**Re: Endangered Species Act, Section 7 Consultation:
U.S. Nuclear Regulatory Commission, Pilgrim Nuclear Power Station,
Plymouth, Massachusetts: Relicensing**

RE: MCZM review of the Entergy-Pilgrim Station § 316 Demonstration Report.

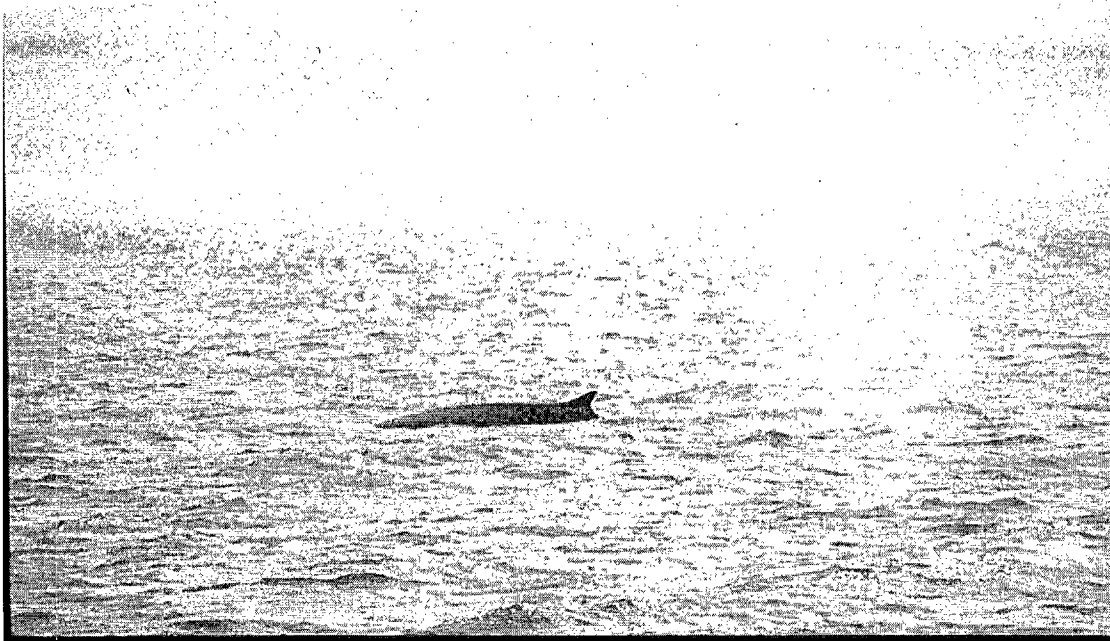
Second, the biological assessment ignores scientific data readily available **about whale activity in the area**. For example, a quick review of available data produced this photo of a federally endangered fin whale (*balaenoptera physalus*) in front of PNPS. The NRC's biological assessment contains a scant half page of "assessment" of the impacts of PNPS on the fin whale. NUREG-1437, p. E-71.
